CITY OF CONWAY, ARKANSAS HISTORIC DISTRICT COMMISSION

November 23, 2020 · 5:30pm · City Hall · 1111 Main Street

Ingram Hartje House - Exterior Modifications

New Single-Family Residence

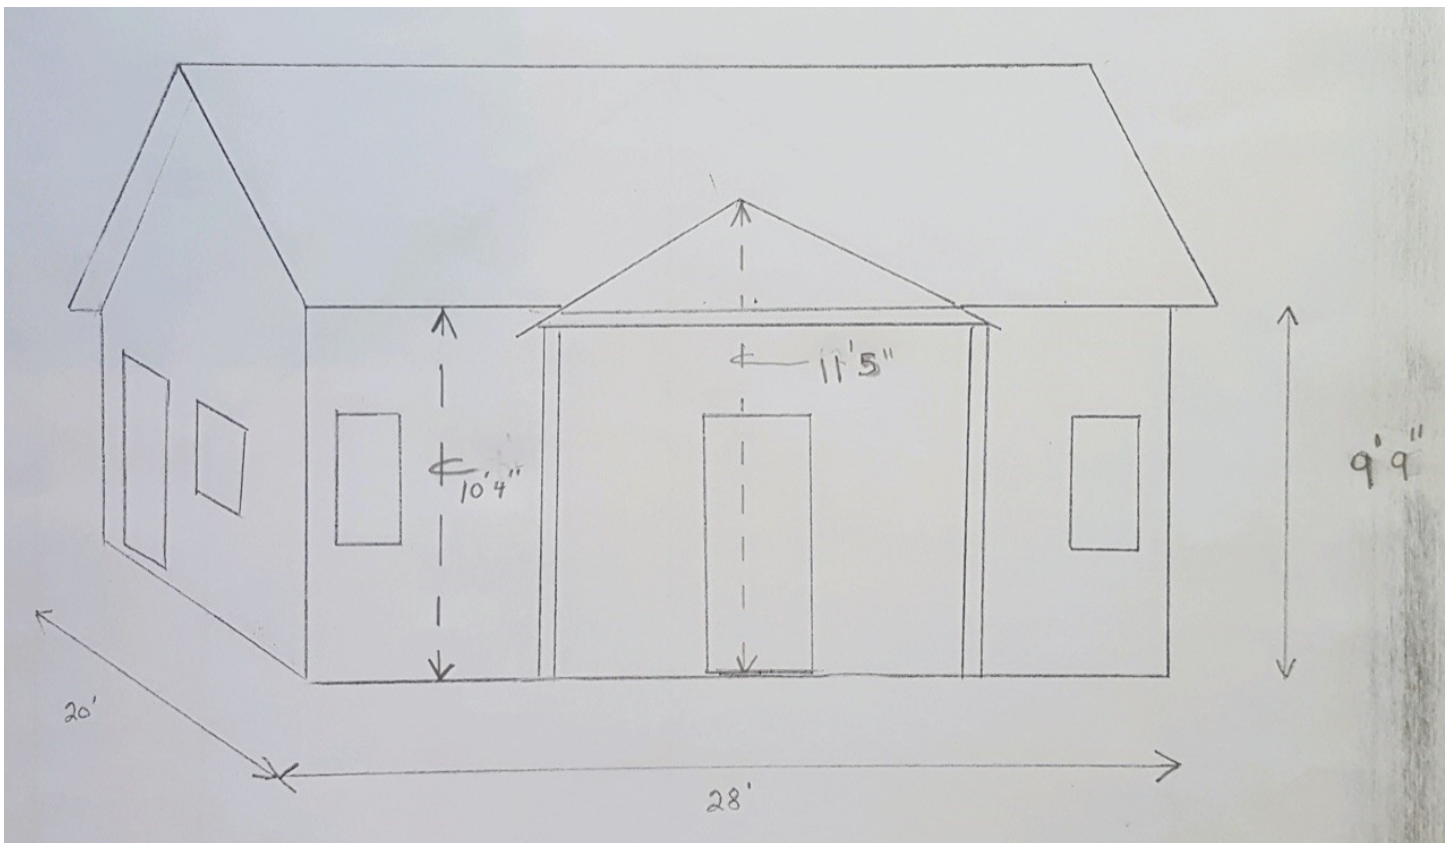
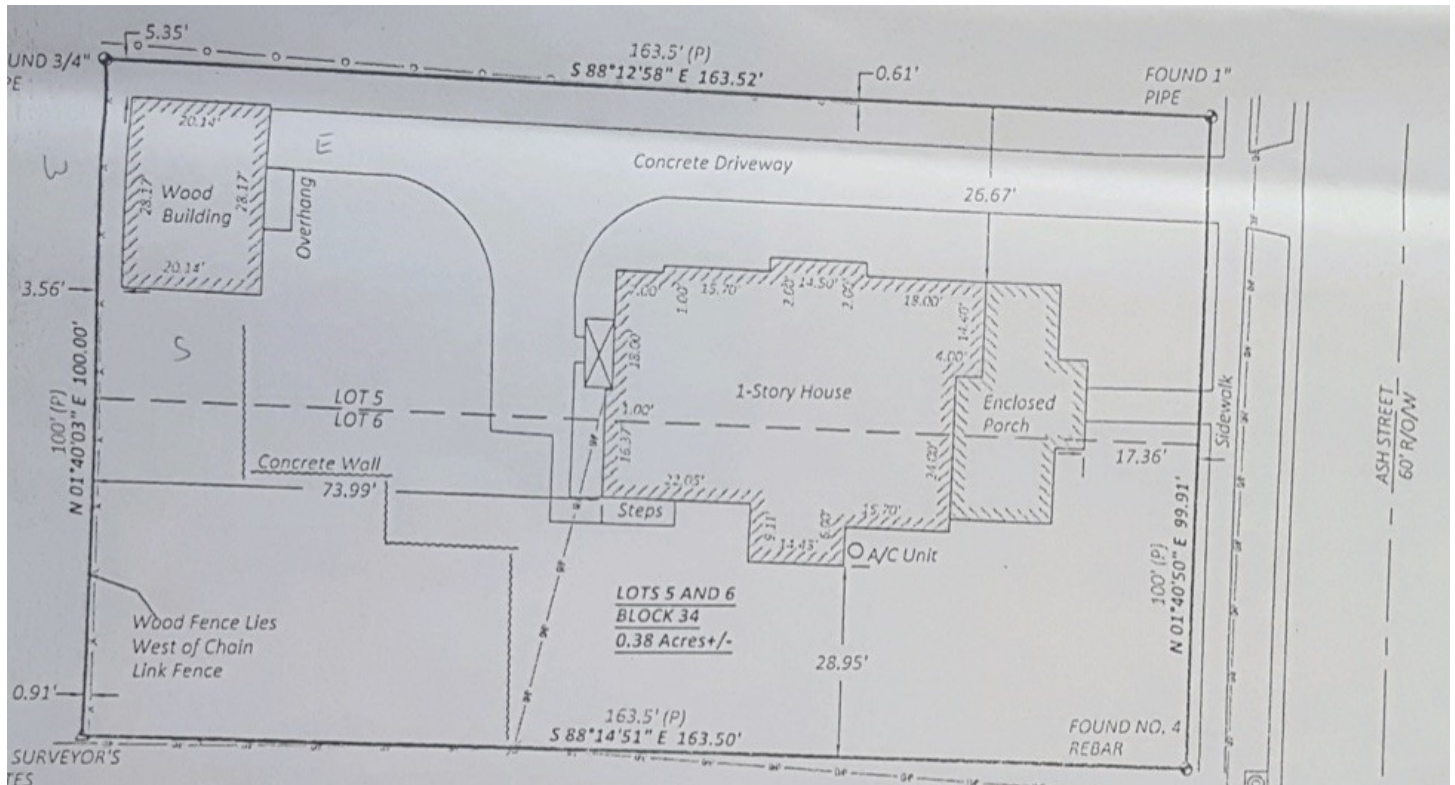
No changes to the existing windows are proposed except to restore existing materials. It appears a matching window will be added on the north side of the front façade of the accessory structure. Any window which is added should match the form of the window on the south side of the front façade. The door on the south side of the front façade will be relocated to the center of the structure.

The proposed changes will not significantly alter the character of the structure and will honor the structure's original design, while allowing it to transition away from an outmoded use as a garage, as it is not likely large enough to accommodate modern vehicles.

1. Any window which is added should match the form of the window on the south side of the front façade.
2. HVAC and utility equipment shall be appropriately located at the rear or side of the structure and/or appropriately screened.

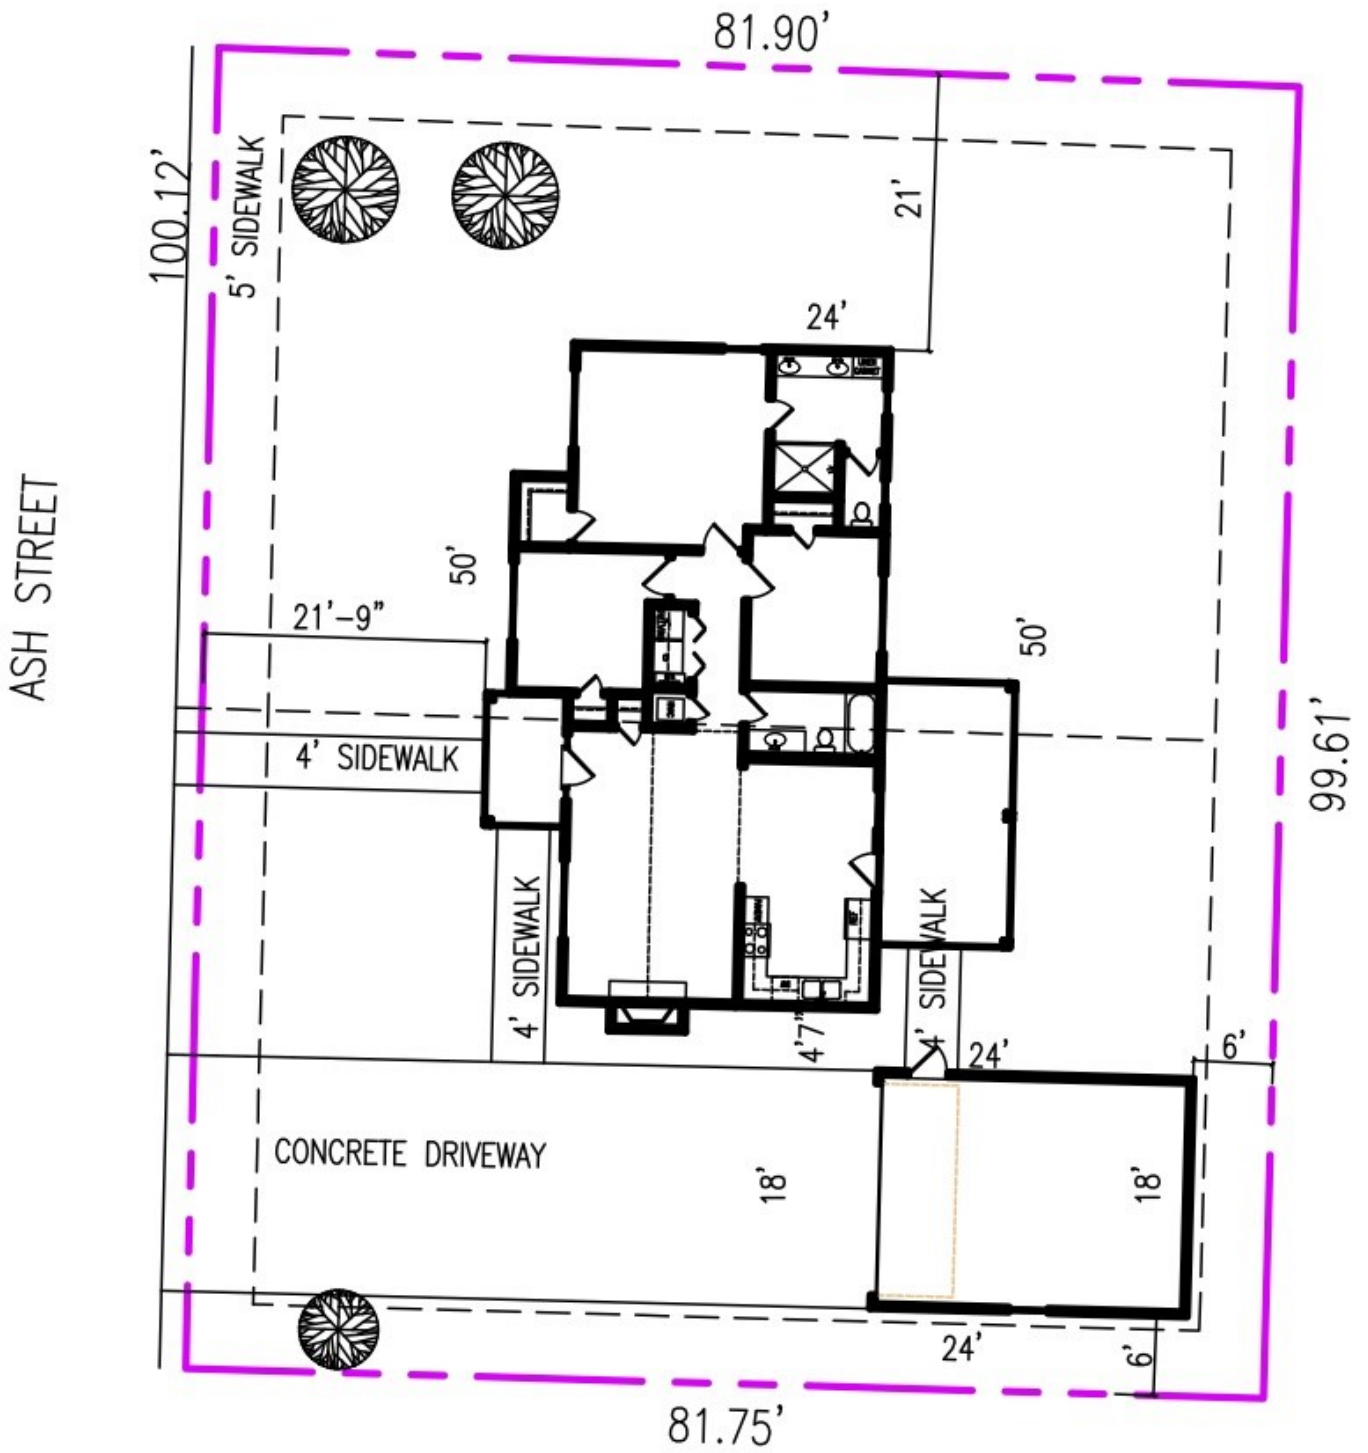
The applicant is proposing an 18' concrete driveway. This is due in part to the existing wide apron at the street.

The height of the structure at 18' and the width at 50' will not be out of scale of the pattern of the neighborhood. The structure will be one story. There are predominantly one-story structures in the immediate vicinity. The area features primarily horizontally oriented structures.

The front façade will be composed of 26% windows and openings, which based on design appears to be appropriate. The side facades have a single window each.

An open front porch with a 6' depth is proposed. No details on the style of windows is provided. It is anticipated vinyl are proposed, which would be required to be of 1 over 1 design.

The applicant is proposing to use brick along the base of the structure with HardieBoard on the remainder of the structure. Recommend requiring additional spacing between the base of the windows and the brick base.

Roof forms and materials are appropriate. The applicant is proposing 7:12 roof pitching, which is appropriate.

1. Require a 12' driveway that widens to 18' at the front of the house.
2. Require the planting of three canopy trees in the front yard.
3. Require windows to be true divided lights or 1 over 1 if not true divided light.
4. Require 5' sidewalk with a 5' setback from the back of curb.
5. Require fascia and soffits to be finished with wood construction or wood equivalent such as HardieBoard.
6. HVAC equipment be placed in a manner to minimize its visibility from the street.

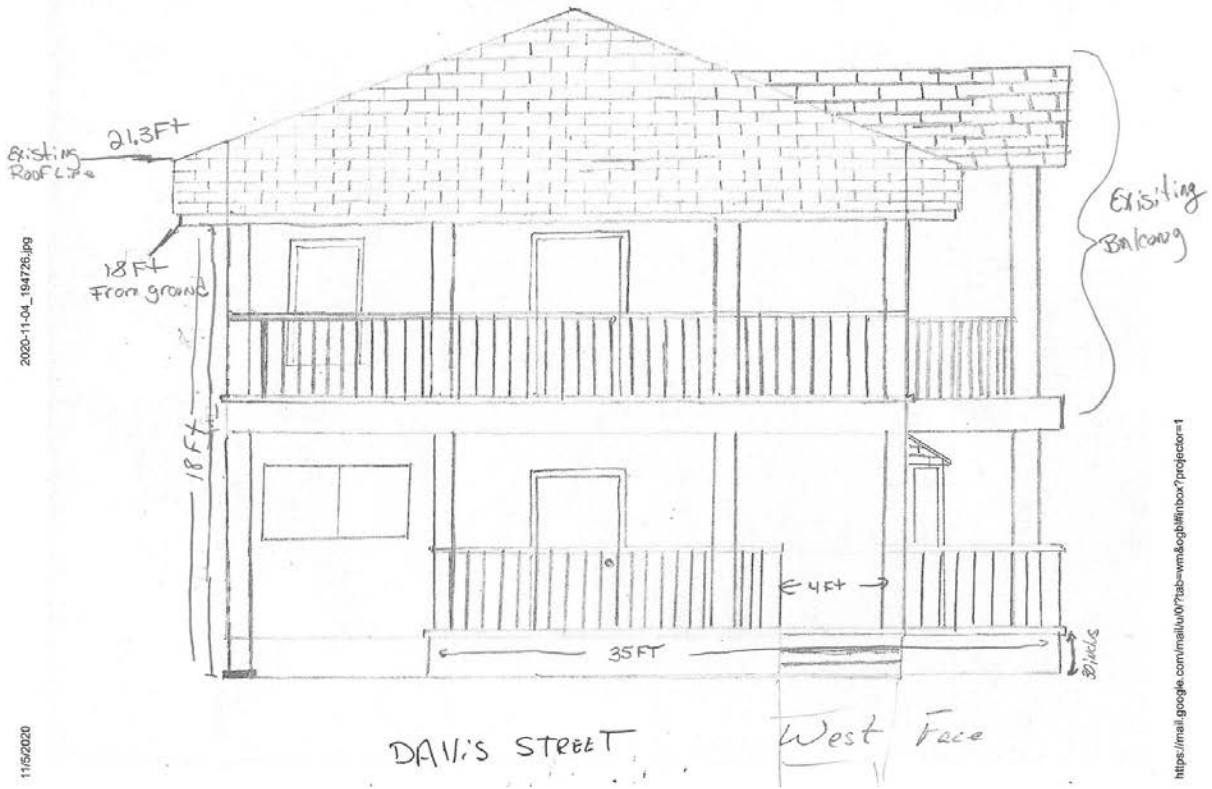
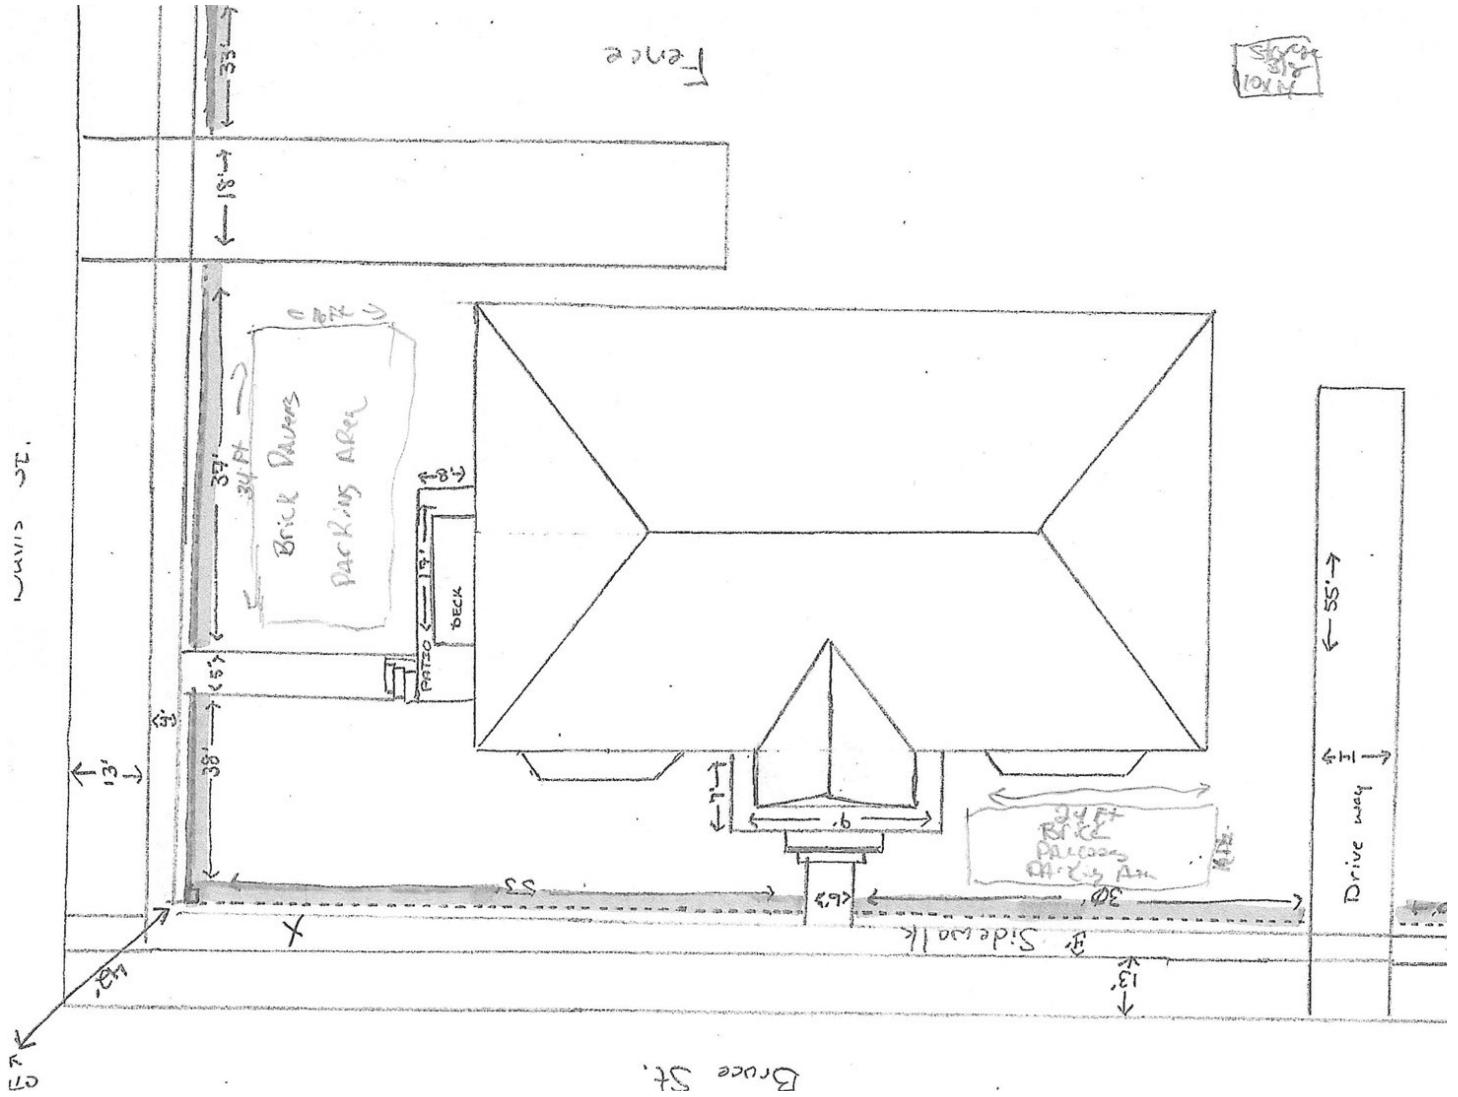
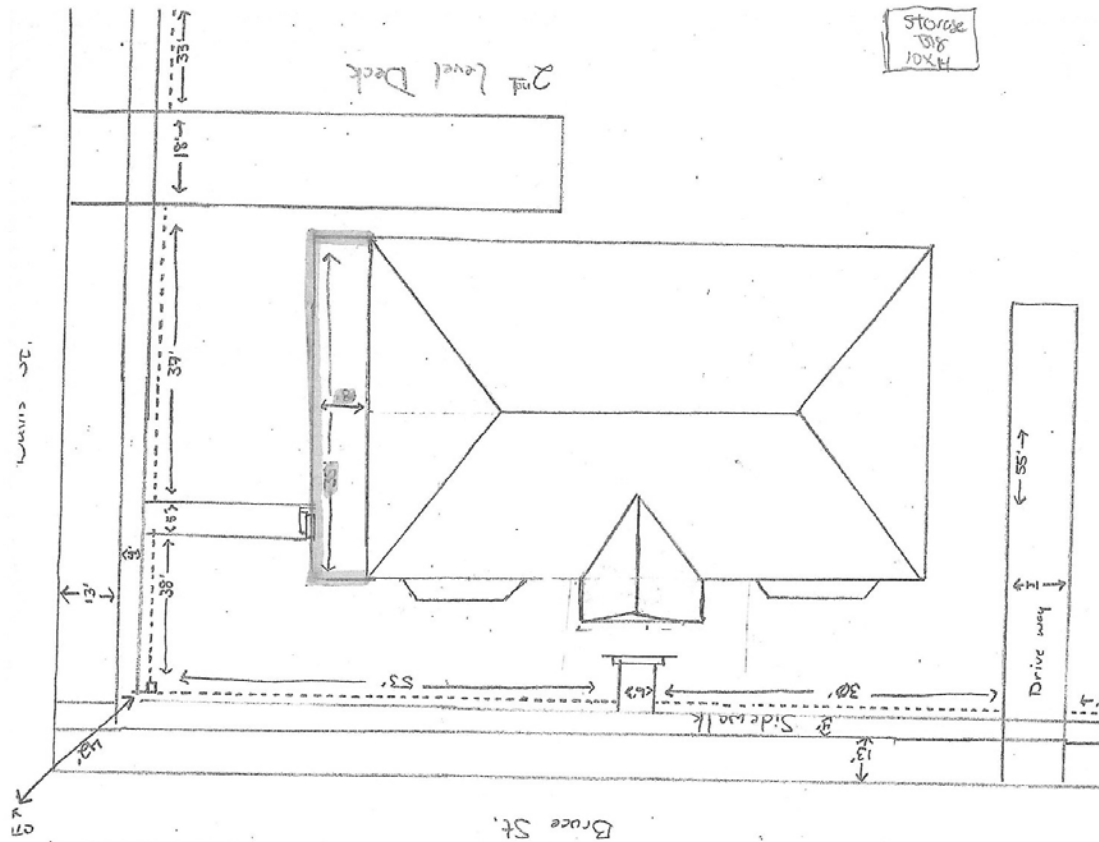
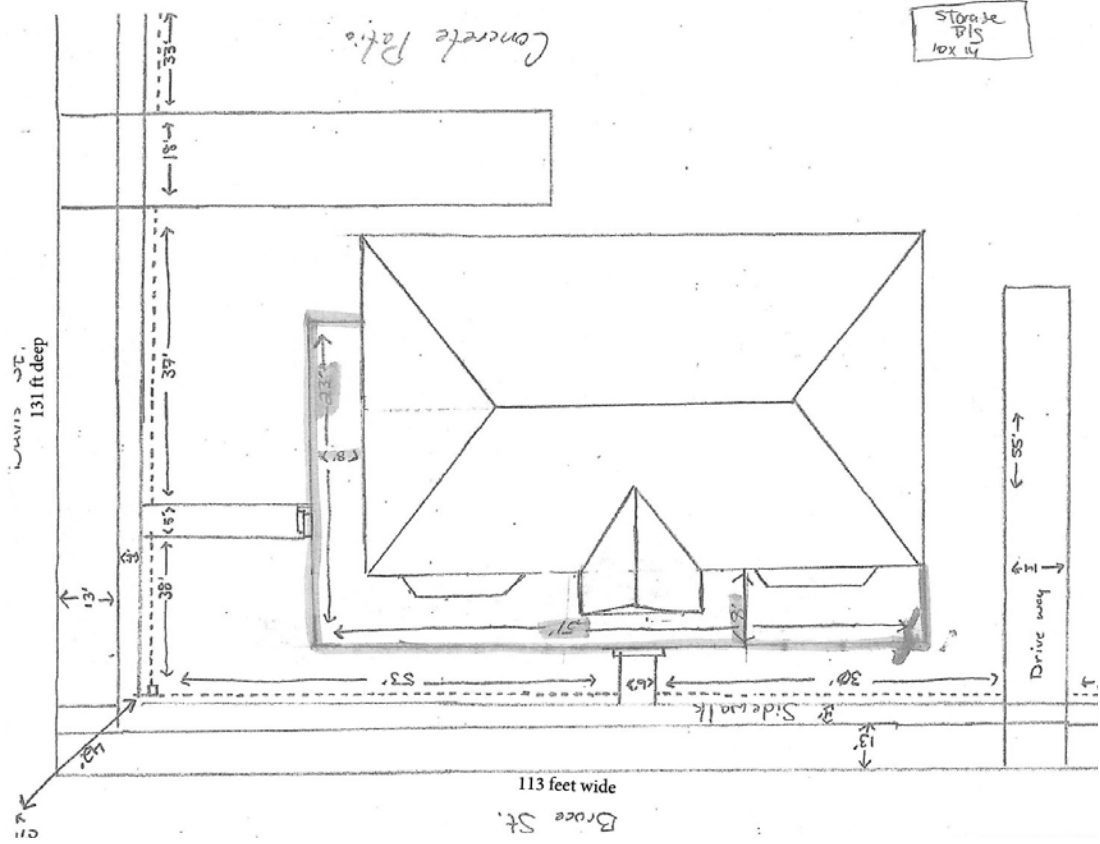
The area is comprised of thoughtfully designed houses with detailed articulation relating to the specific architectural styles. The proposed modifications would significantly impact the existing form of the house as viewed from the public realm.

Limited information as to the height and materials of the proposed fence were provided. Staff has recommended a condition of approval requiring that the applicant submit additional information to the Director of Planning ensuring compliance with this section of the Overlay District.

The applicant is proposing two parking areas located in the front and street side yards. This change would have a significant visual impact given the prominent corner location of the site. The proposed parking areas are located inappropriately and should be relocated behind the structure.

The applicant is proposing to construct a wrap around porch on the front and eastern side of the house with an 8-foot depth and picket railing. Limited information was provided in regard to the proposed materials. Staff has included a condition of approval requiring that additional plans/information be submitted to the Planning Director to ensure compliance with the standards of the Overlay District.

The proposed balcony/deck on the eastern elevation includes a 10-foot extension of the roof along that side of the house. The proposed roof materials were not provided. The proposed extension of the roof is inconsistent with the traditional symmetry associated with the house's neo-classical architectural style and would be inappropriate.

The applicant is proposing to construct a new elevated deck on the second floor of the structure along the eastern side of the house with a depth of 8-feet. Expansive elevated decks are not a traditional element featured on neo-classical structures. Three small elevated balconies currently exist on the front and both sides of the structure. It is the opinion of staff that further expansion of the elevated deck would make it a dominating focal point on the street facing facades and would significantly alter the streetscape. This modification would be inappropriate in this context.

Staff recommends disapproval of the proposed elevated deck and roof modifications.

1. Detailed fencing plans shall be submitted to the Planning Director ensuring compliance with the fencing height, placement, and materials standards of the Overlay District.
2. Additional information or plans shall be submitted to the Director of Planning detailing the proposed materials of the porch and associated railing.
3. Information shall be provided to the Planning Director describing the anticipated impact on any existing trees. A replacement tree shall be planted for every tree over 8" in diameter that is removed.
4. Revised parking plans shall be submitted to the Planning Director demonstrating compliance with the location requirements of the Overlay District.
5. Plans shall be resubmitted to the Planning Director for approval prior to issuance of the COA.
